Second Five-Year Review Report

for
McGraw Edison Corporation
Albion, Michigan
October, 2004

U. S. EPA - REGION 5

MDEQ's Comments to the December 2003 and April 2004 Soil and Groundwater Sampling Results

FIGURE 2

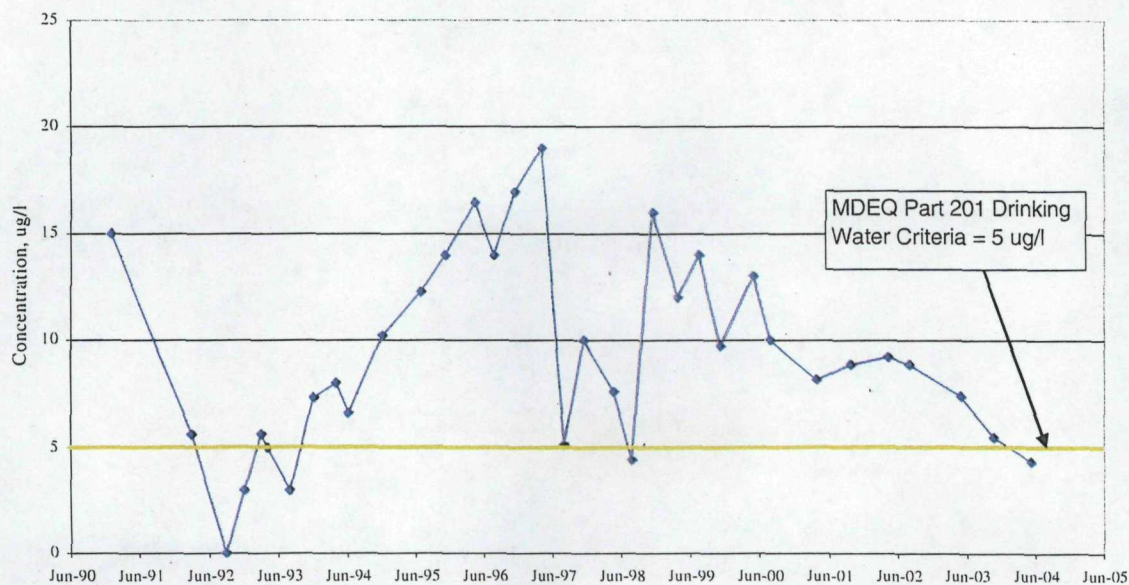
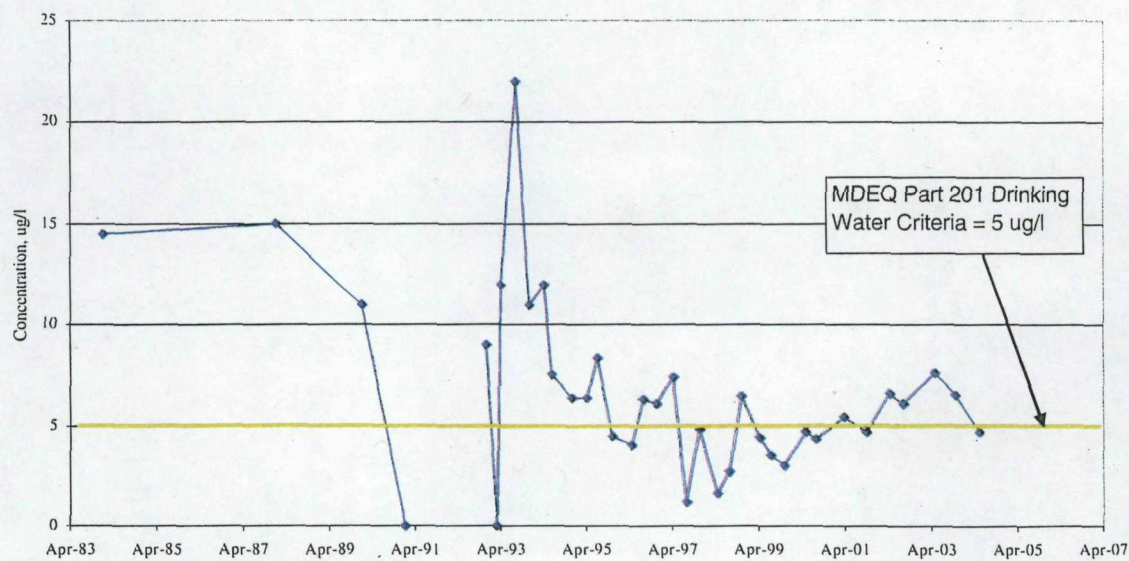
2. Install additional monitoring wells where data gaps exist. Additional monitoring wells are needed at three locations in areas of concern where capture of contaminated groundwater has not been clearly demonstrated.

has yet to fulfill. Page 5, second paragraph of the last five-year review report states that “Additional monitoring wells are needed in areas of concern where capture of the contaminated water has not been clearly demonstrated.” There are three locations where data gaps exist and additional wells are required; near the intersection of Barnes Street and Clark Street, near monitoring well B-49S and south of well B-41S. Geoprobe work completed by Cooper Industries in 1999 or 2000 showed that there did not appear to be contamination in shallow aquifer groundwater in the areas of the temporary borings on Linwood Avenue. The investigation did not penetrate the bedrock surface, so there is no evidence of a lack of groundwater contamination in the bedrock aquifer in these areas. There are no bedrock aquifer wells in these areas to confirm hydraulic containment of the contaminant plume. The MDEQ is still concerned with the containment of the shallow aquifer contaminant plume due south of well B-46S. The data from the existing wells is not conclusive. The MDEQ recommends additional well clusters to be installed to make certain the plume has been captured. The concentration of contaminants versus time plots for wells down gradient and outside the capture zone (B-46S, B-47S) indicates elevated concentrations of contaminants with time (Figure 2). If these wells are outside the capture zone, the concentration of contaminants should go down with time, but this has not occurred until recently (1998-2003 for B-46S). Monitoring well B-47S indicated a decrease in concentration from 1994 to 1998, but is indicating a moderate increase from 1999 to 2004.

FIGURE 3

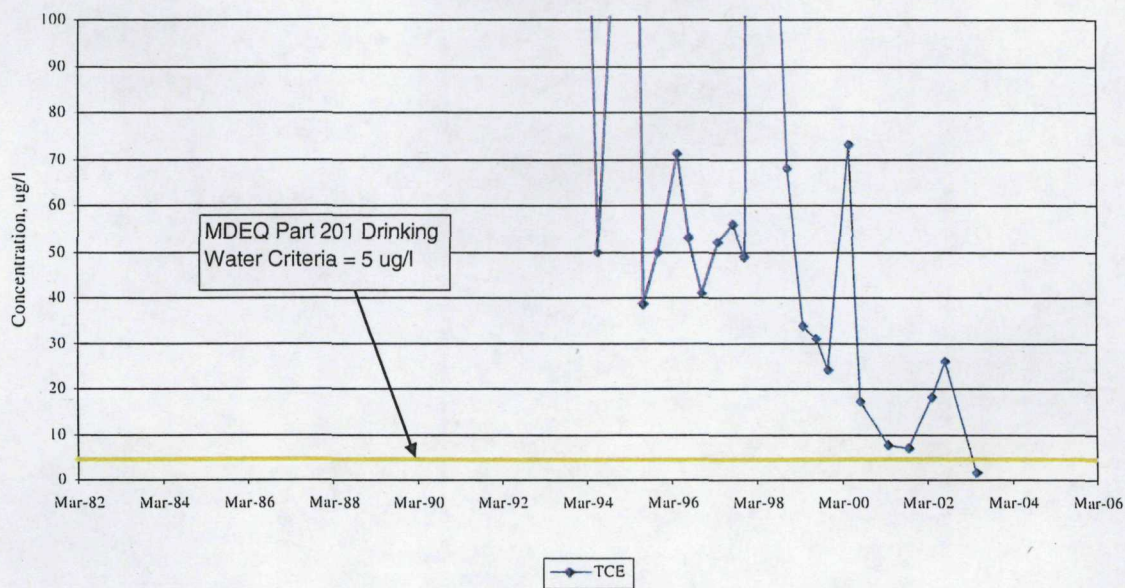
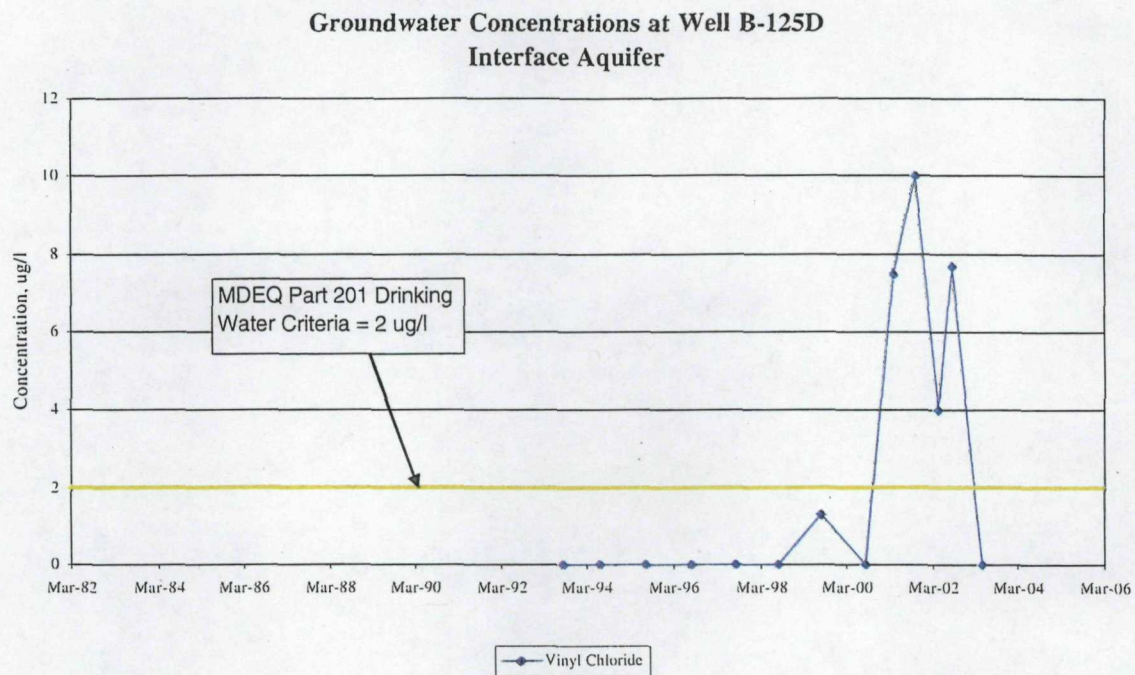
Two monitoring wells (B-42S and B-125D) indicated elevated concentrations of contaminants (trichloroethylene, perchloroethene, and vinyl chloride (Figure 3)). Cooper Industries states that the wells have been impacted from offsite sources (B-42S – Brooks Foundry; B-125D – Albion Industries). The MDEQ recommends that Cooper Industries investigate the source of this contamination to substantiate the claim that the contamination is from an offsite source and not from the McGraw-Edison site.
